IMPORTANT SAFETY RECALL NOTICE

Ref: Safety Recall - (NHTSA Recall No. 24V296)

Technical Bulletin TB1816, Rev A

Hopper Rear Door Pin Replacement

Fig 1 Pin – Hydraulic cylinder pivot

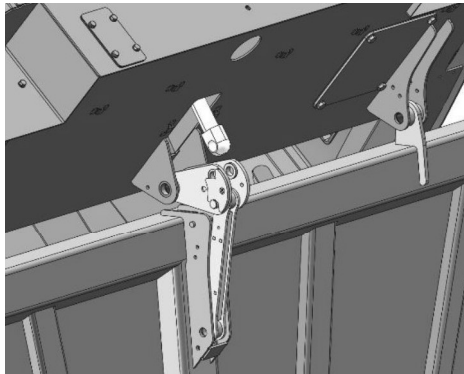
A replacement pin has been designed from a high strength, high hardness, corrosion resistant stainless steel to eliminate the potential for corrosion to affect the pin integrity over time. The new pin is from polished and ground stainless steel and silver in colour whereas the old pins had a black finish. There is also an indent machined into one end of the new pin so it can be distinguished from the original even when installed see Fig 1.

Figure 1 – Location of Retaining Bracket installed.

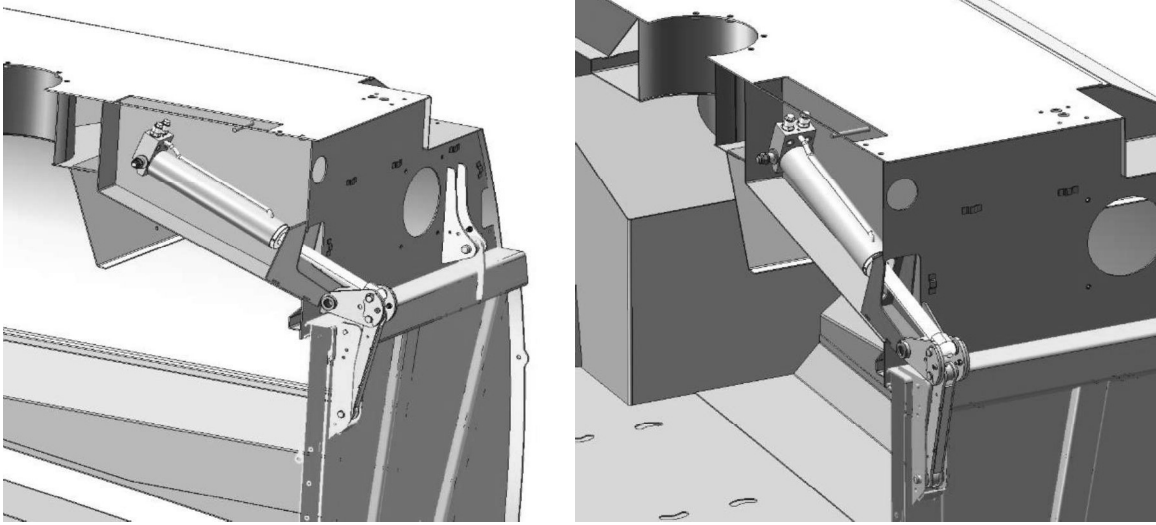
7. Switch vehicle ignition off and remove key from ignition.
8. By hand, raise the cylinder rod upwards to allow the retaining bracket to be inserted over the cylinder rod. Locate the retaining bracket into the hopper aperture with the circular cut outs against the linkage pivot – See Figure 1.

10. Switch vehicle ignition off and remove key from ignition.
11. Elevate cylinder rod end and use a tie wrap across cleats to temporarily support the rod end - See Figure 2.

Figure 1 – Location of labels installed both sides

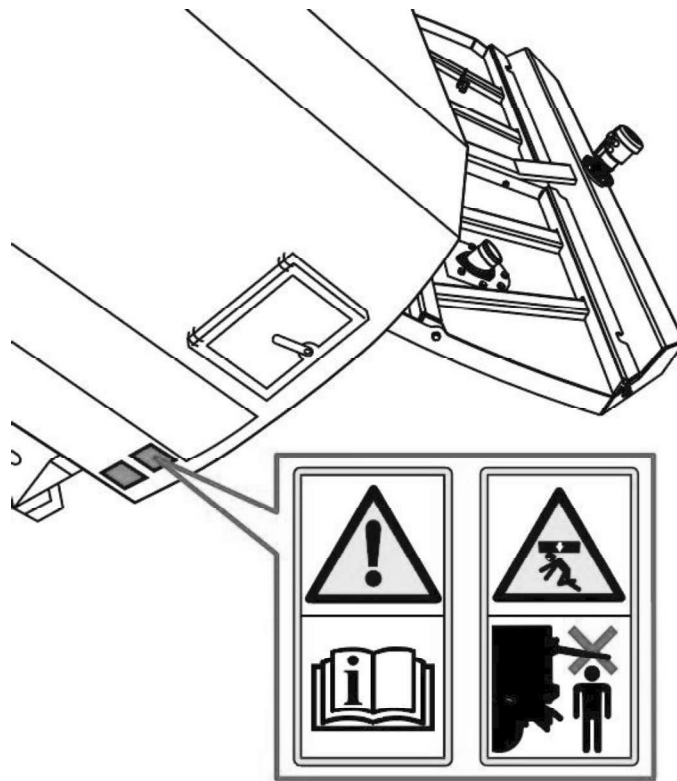
1. With the door in a fully closed position and the body (hopper) down, clean the surface and affix a label to each side of the body in the position shown (Figure 1).
